Bulletin No. 2003-10

## Hairpin Cotter 18-859746 is NLA

Qty. 1 of 18-32857-1 cotter pin for transom shift cable retention.  mc79777

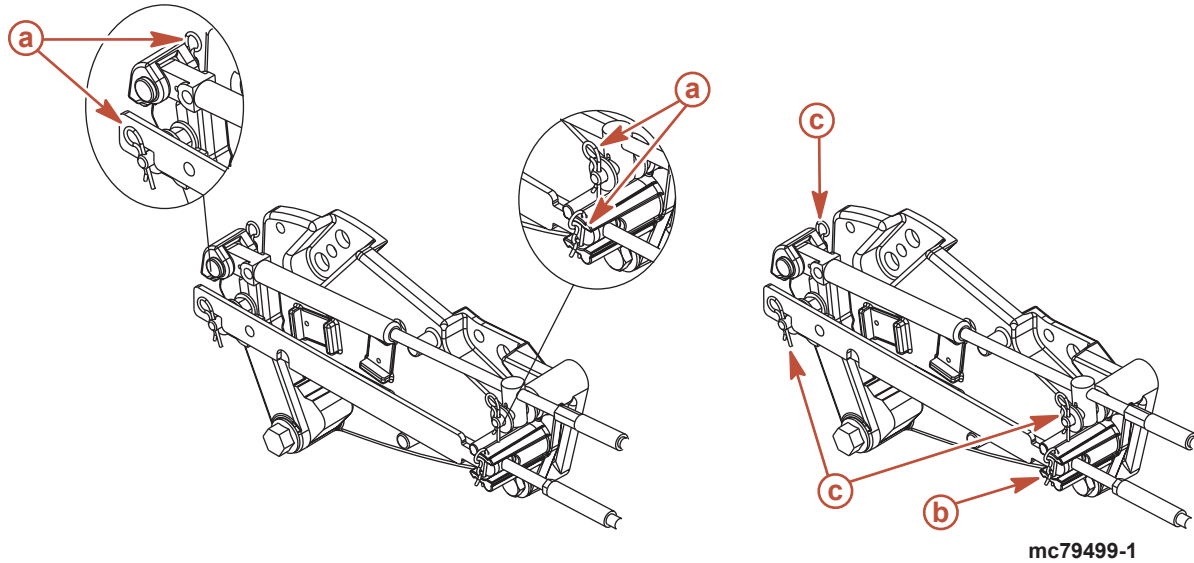
Hairpin cotter 18-859746 that retains the shift cables on the shift plate assembly on all MCM engines must be replaced with (1) of 18-32857-1 cotter pin at the shift cable anchor on the Alpha switch actuating arm and Bravo shift cable retainer plus (3) of 18-21071-1 cotter pins for the two studs and the clevis pin on the shift lever of both the Alpha and Bravo shift plate assemblies.

Qty. 3 of 18-21071-1 cotter pins for shift lever clevis pin and studs.  mc79778
